PLANNING APPEAL
PROPOSED INTEGRATED WASTE MANAGEMENT FACILITY AT
WHITESTOWN LOWER, COUNTY WICKLOW (PL 27.211913)

ASSESSMENT OF THE PROPOSED DEVELOPMENT IN RELATION TO SITE
SUITABILITY AND HYDROGEOLOGY

REPORT FOR AN BORD PLEANALE

David M. Ball Hydrogeologist
28 New Bride Street, Dublin 8

Figure 3 Cross Sections with commen

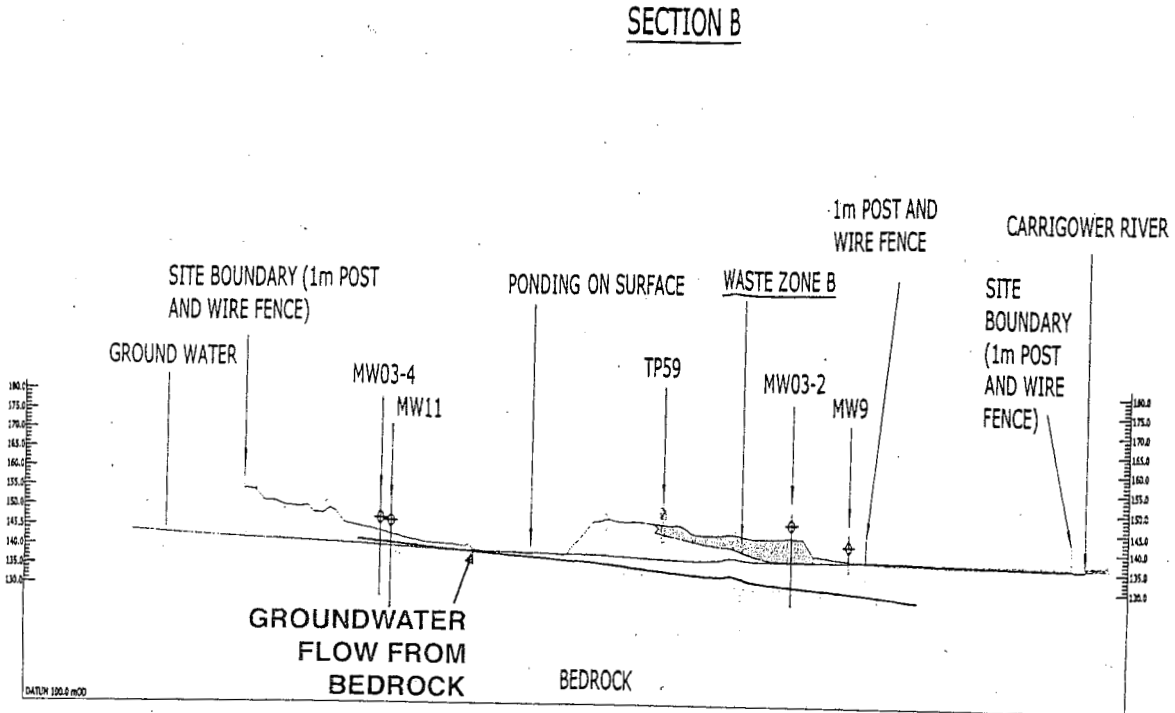
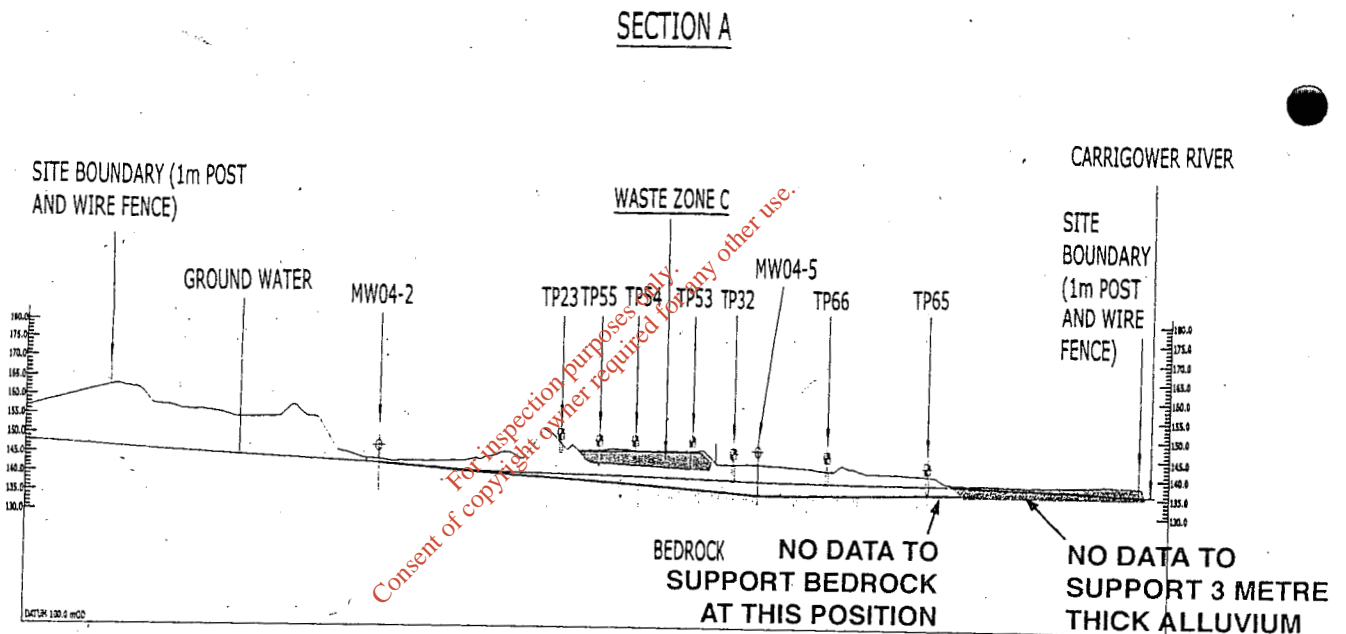
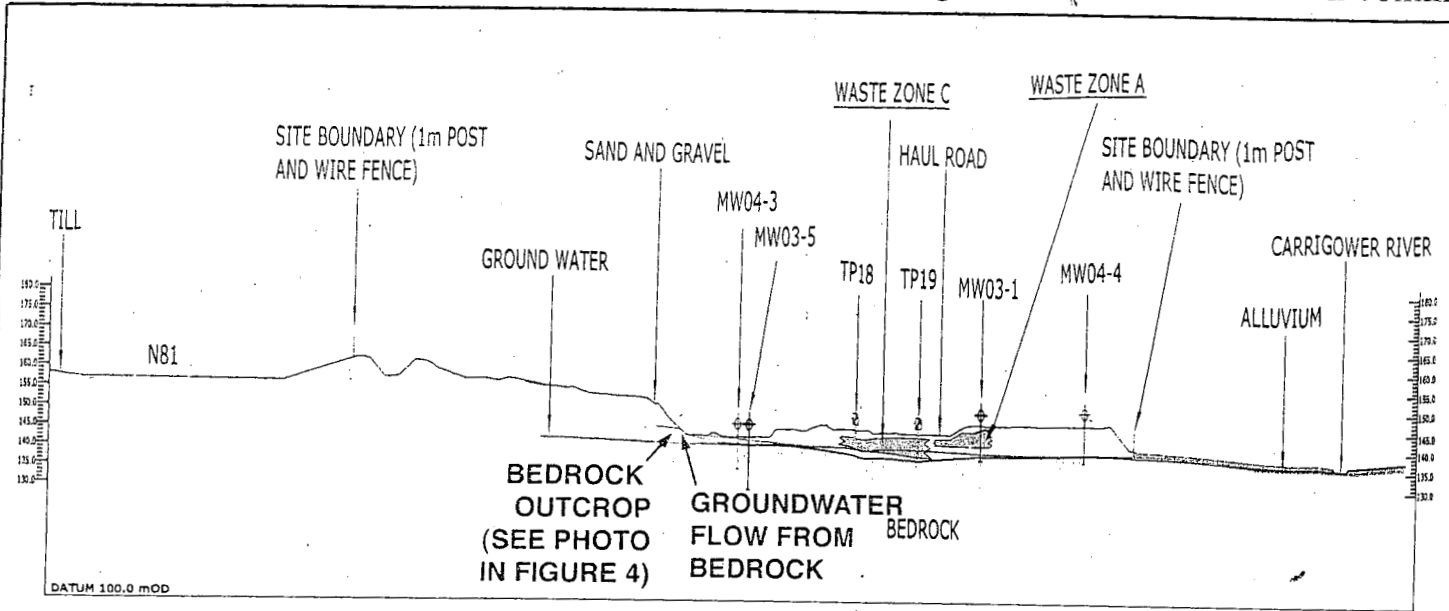
The applicant has presented cross sections through the site in figure 3.7.5. I have scanned and compressed the horizontal scale of these sections in order to reproduce them for ease of reference as an A4 figure (Figure 3). It can be seen that they have been compiled using trial pit and borehole information. However there are very few detailed reference boreholes that fully penetrate the overburden and or waste and define the position of the bedrock. It can be seen that the sands and gravels shown in yellow form a thick layer below the alluvium in the southern section C. The other sections imply that the bedrock is close to the surface and the sands and gravels terminate abruptly at the edge of the flood plain. There does not appear to be any data to support this.

The southern section C has a comment by the applicant that there is 'Ponding on Surface' at the north western end of the section on the quarry floor. During my site visit on the 22nd July 2005 I found that bedrock is exposed in the floor of the quarry at this point and groundwater is flowing from the rock, across the surface and then ponding below a gravel cliff. The water is seeping away into the gravel aquifer.

Neither spring, nor the northern outcrop, are shown on the cross sections presented by the applicant.

Figure 4 Butter Mountain Slate bedrock outcrop and spring at northern end of Quarry

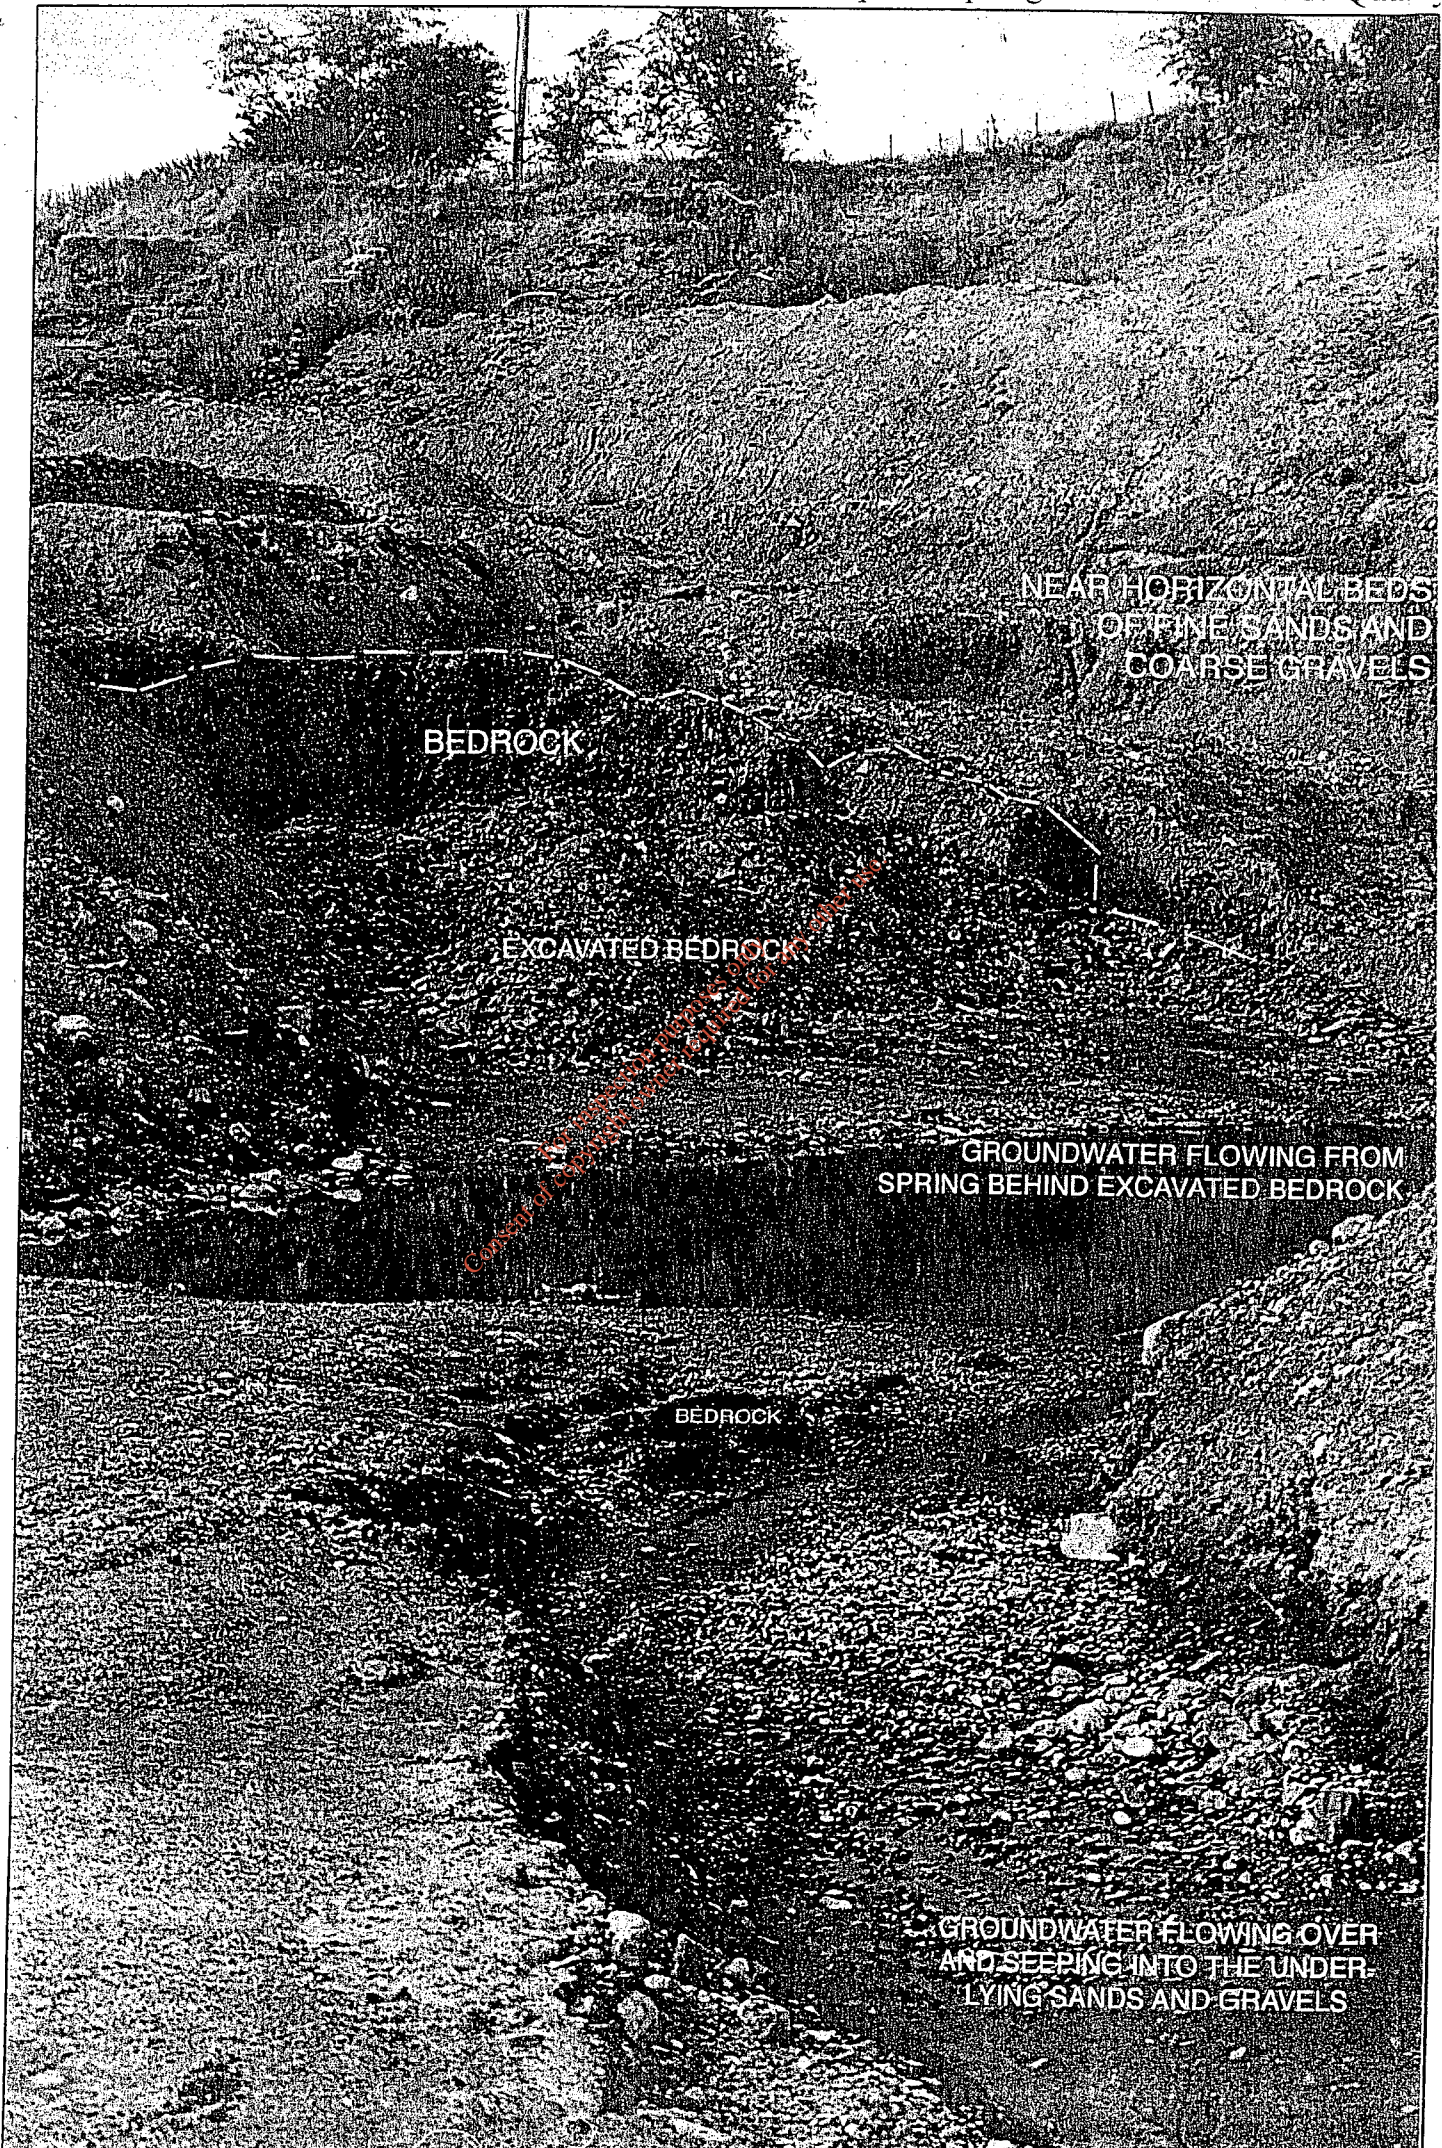
During the same visit I observed a substantial outcrop of shattered and weathered Slates at the northern end of the quarry, roughly on Section A. This outcrop appears to have been partly excavated to reveal a large spring seepage face. These two springs from the bedrock are noted in my comments in red on the cross sections. The northern spring and the outcrop of slate are shown in the photographs taken on the 22nd July in Figures 4 and 5.

Figure 2 Borehole Locations and "indicative groundwater level contours" 3rd February 2004

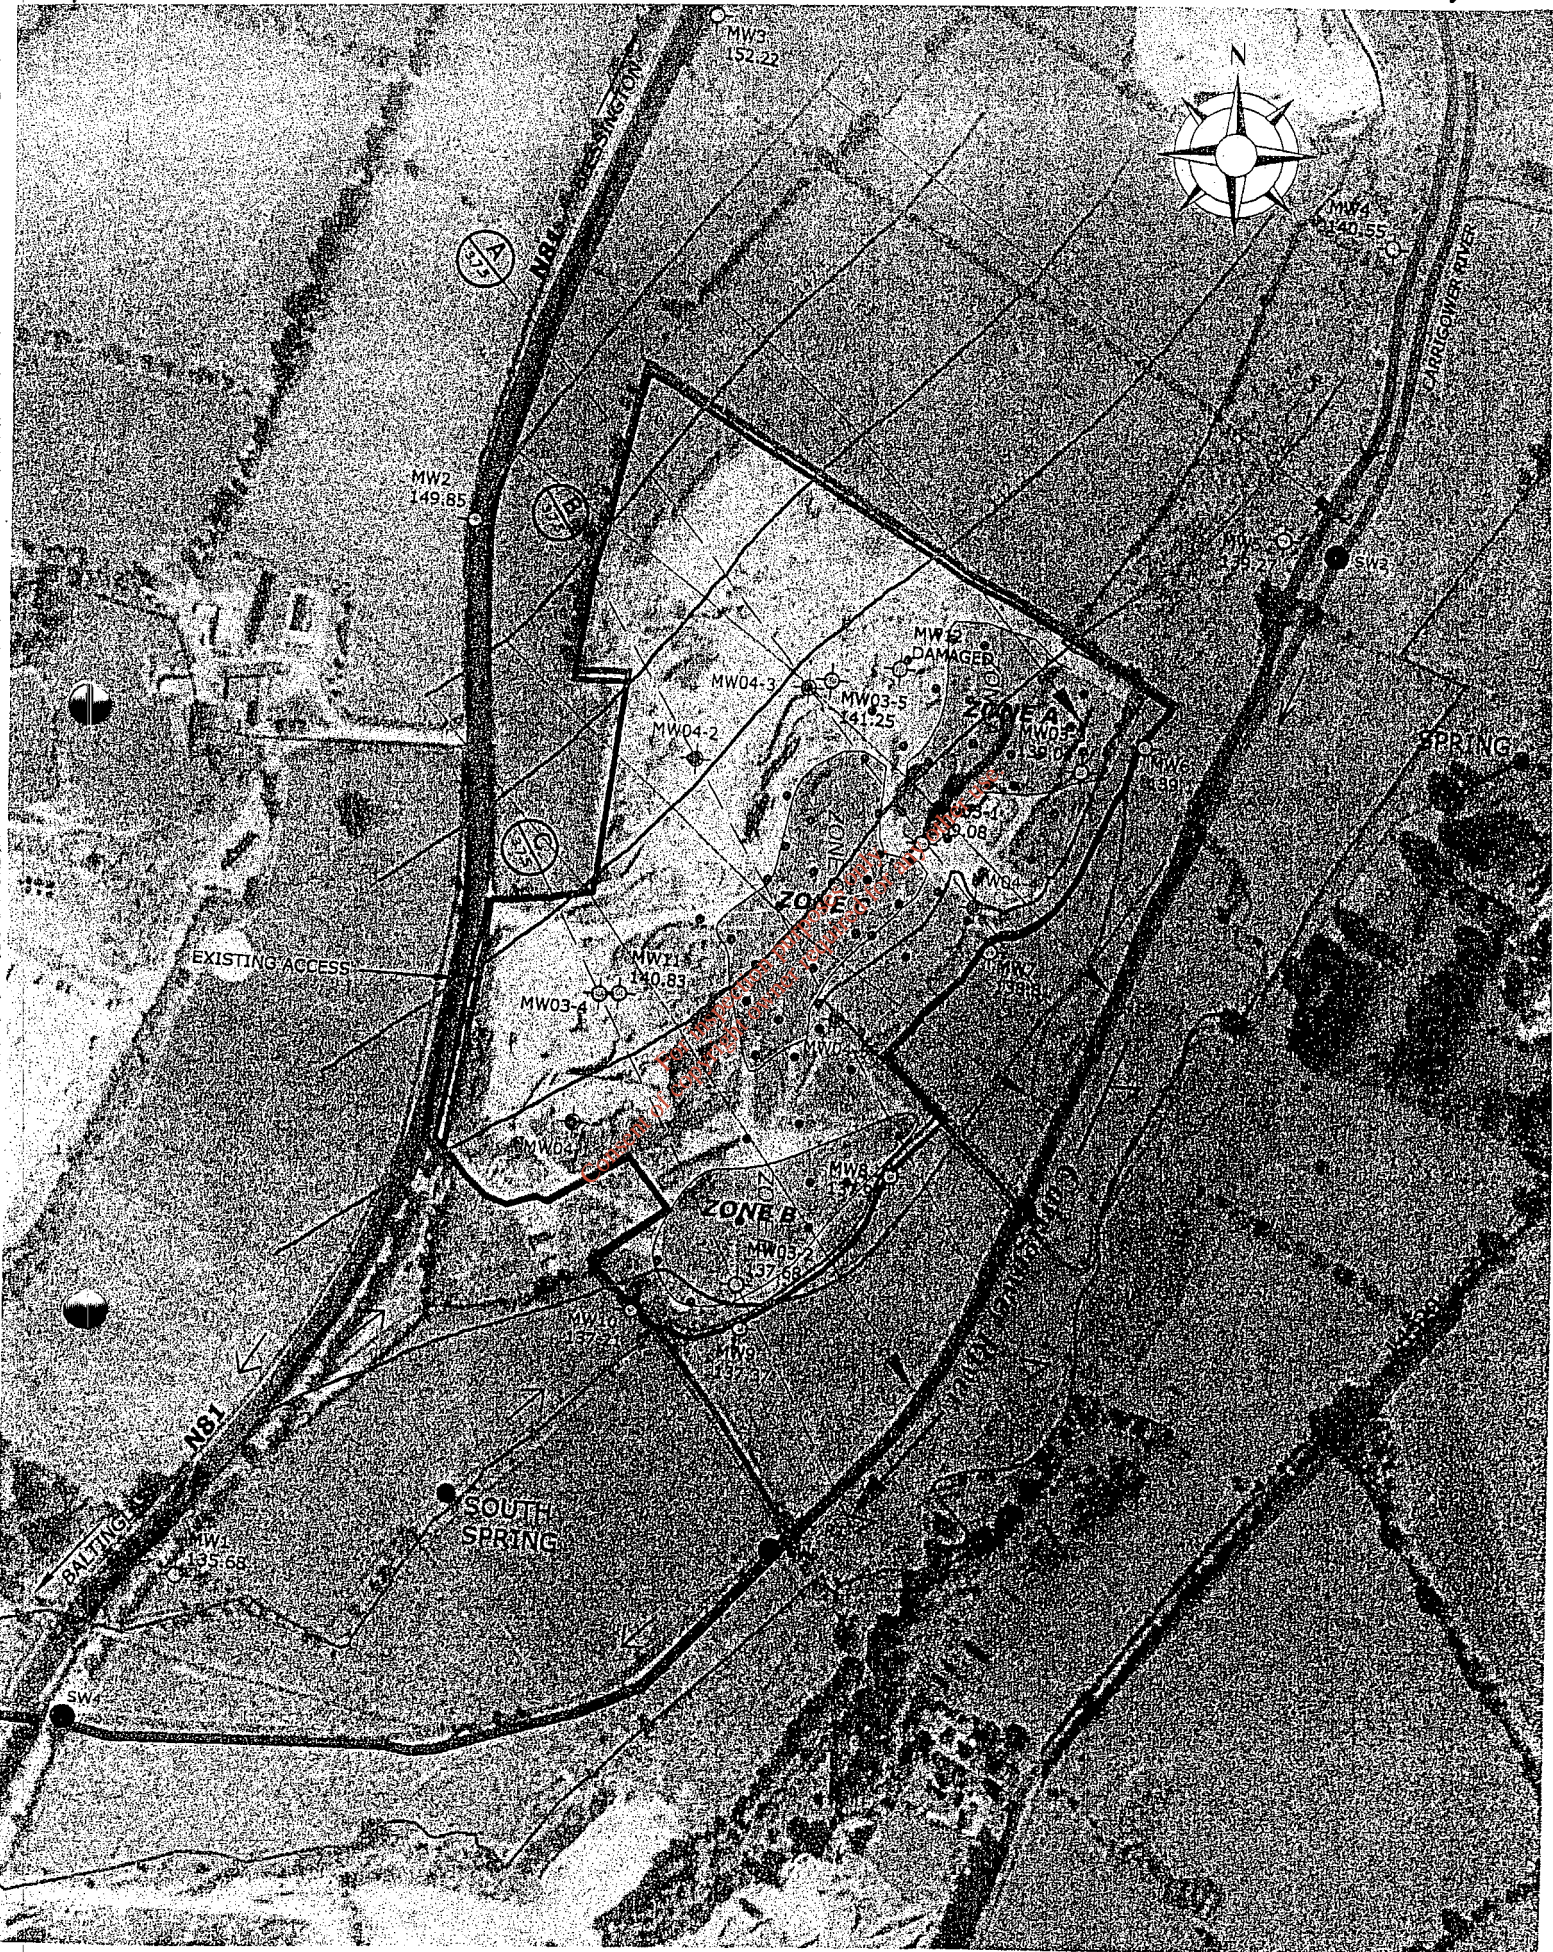
Section 7.4 describes the drilling carried out for the applicant. Five boreholes were drilled. Figure 2 shows a composite map combining a detail from the aerial photograph of the site, with the location of boreholes and the location of the trial pits. The figure also includes 'indicative groundwater level contours' for February 2004 at 2.5 metre contour intervals. These details are copied from figure 3.7.4 in the May 2005 Risk Assessment Report. I have chosen to combine the details from this recent map because it shows groundwater flow direction arrows that indicate flow from the site to the river. The boreholes drilled for the applicant are shown in red, whereas the existing or previous boreholes (for which there is limited construction data) are shown in pink.

The applicant appears to consider the overburden and bedrock aquifers to be in hydraulic continuity, and hence has drawn an 'indicative' water table map that

roughly reflects the water levels in the bedrock and the overburden combined. This appears to be reasonable and justified, and points to a combined groundwater flow system below and through the existing quarry.

It is important to note that the water table elevations shown on the design drawings are based on one set of water level measurements made in February 2004. The water table contours used in the design drawings are not based on measurements that reflect the natural seasonal fluctuation of the water table. These contours do not appear to reflect the spring flow of groundwater observed in the south and north of the existing quarry during my site visit in July 2005. If springs from the bedrock are evident in summer it is likely that they will also occur in winter with a greater flow, and perhaps at a higher level. The spring level in the south appears to be at about 142-143 mOD whereas the groundwater level in detailed design section D (Figure BRI / 114-2) shows the water table at 141mOD.
